UTEG PLACE SUBDIVISION

APPLICATION NUMBER 6 DATE September 6, 2012

REQUEST Subdivision

DETAIL SITE PLAN

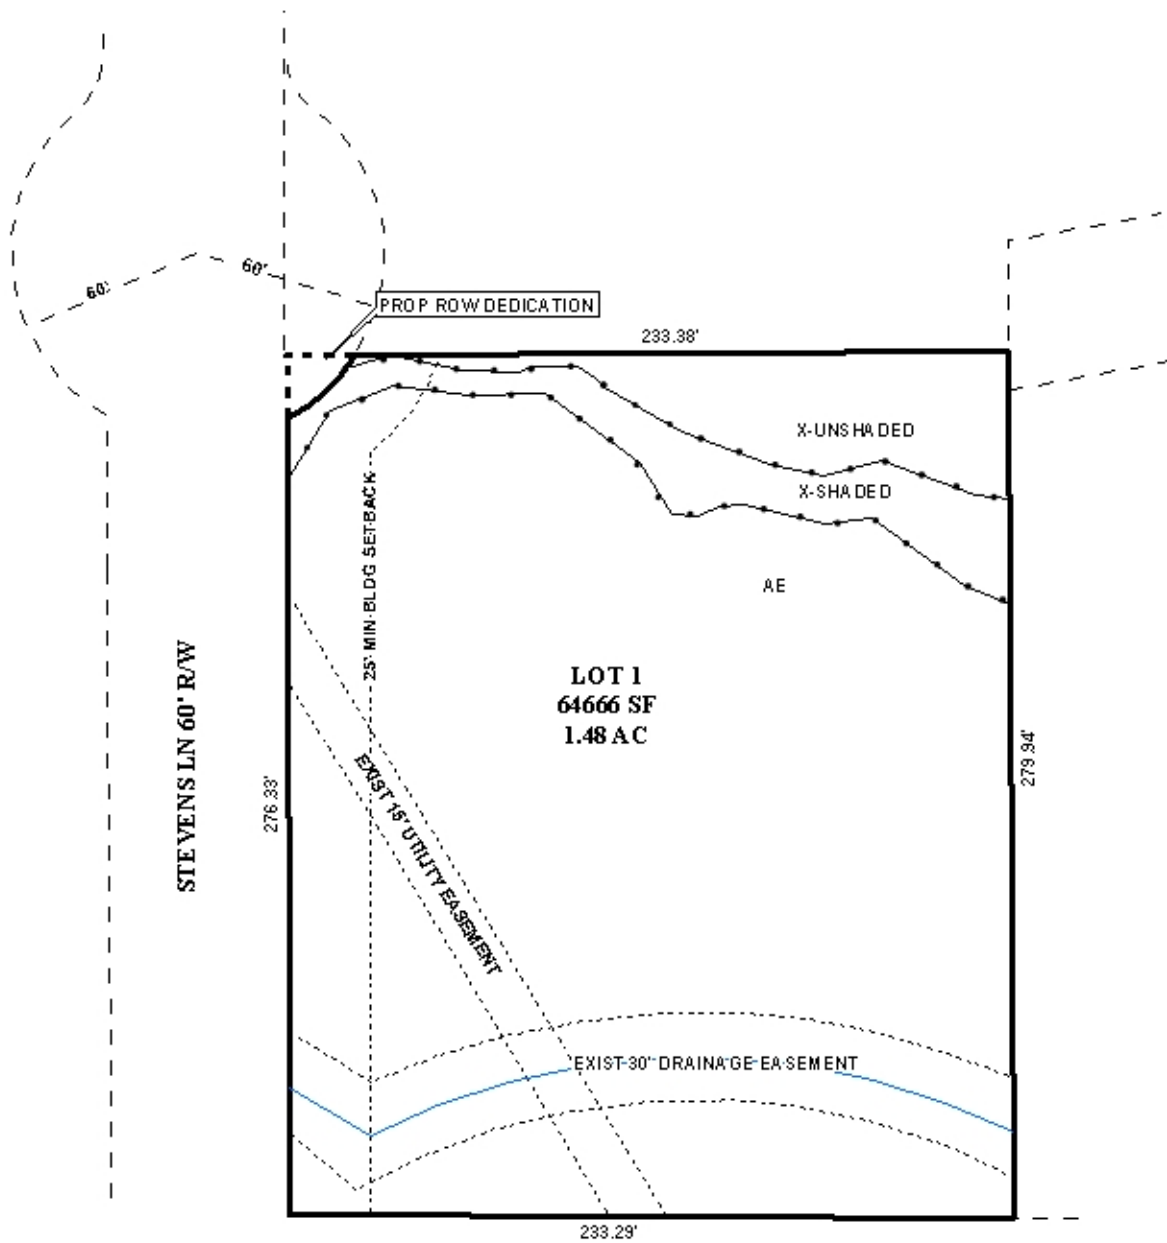
Engineering Comments: The following comments should be addressed prior to acceptance and signature by the City Engineer: 1. Provide topographic information of the existing drainage way and exposed sanitary sewer line to establish/verify drainage and utility easements. GIS topography does not seem to match the existing ground topography. 2. Final size and location of the public drainage easement shall be approved by the City Engineer. 3. Provide all of the required information on the Final Plat (i.e. signature blocks, signatures, certification statements, legal description, required notes). 4. A signature block and signature for the Traffic Engineering Department shall be placed on the Final Plat.

The site fronts Stevens Lane, a minor street with a complaint 60' right-of-way and a half-cul-de-sac terminus along the West side. As the current IFC standard requires a 120' diameter for a non-median cul-de-sac, dedication would be required in the Northwest corner of the proposed lot to provide a 60' radius for the East portion of the cul-de-sac, and such is indicated on the plat. As a means of access management, a note should be required on the Final Plat stating that the lot is limited to one curb cut to Stevens Lane, with the size, location and design to be approved by Traffic Engineering and conform to AASHTO standards. As on the preliminary plat a note should be required on the Final Plat stating that the lot is denied access to Carre Drive South, an unopened public right-of-way, until such time that it is developed to City standards. As on the preliminary plat, the Final Plat should illustrate the 25' minimum building setback line along Stevens Lane. The plat should be revised to also illustrate a 25' by 25' building setback line block-out in the Northeast corner of the lot at the West terminus of Carre Drive South. The lot is labeled on the plat with its size in square feet and acres and this should also be done on the Final Plat, or a table should be furnished on the Final Plat providing the same information.

The plat indicates a 15' utility easement and a 30' drainage easement across portions of the site; therefore, these should also be shown on the Final Plat and a note required stating that no structures are to be placed within any easements.

- 1) dedication of sufficient right-of-way to provide a portion of a 60' radius cul-de-sac in the Northwest corner of the property;
- 2) placement of a note on the final plat stating the lot is limited to one curb cut to Stevens Lane, with the size, location and design to be approved by Traffic Engineering and conform to AASHTO standards;

- 3) placement of a note on the Final Plat stating that the lot is denied access to Carre Drive South until such time it is developed to City standards;

- 4) illustration of the 25' minimum building setback line along Stevens Lane;, revised to show a setback around any dedicated cul-de-sac radius at the South terminus of Stevens Lane;

- 5) revision of the plat to illustrate a 25' by 25' minimum building setback block-out in the Northeast corner of the lot at the West terminus of Carre Drive South;

- 6) labeling of the lot with its size in both square feet and acres, or the furnishing of a table on the Final Plat providing the same information;
- 7) illustration of the 15' utility easement and the 30' drainage easement on the Final Plat;

- 8) placement of a note on the Final Plat stating that no structures are to be placed in any easements;
- 9) placement of a note on the Final Plat stating that approval of all applicable Federal, state and local agencies for endangered, threatened or otherwise protected species is required prior to the issuance of any permits or land disturbance activities;
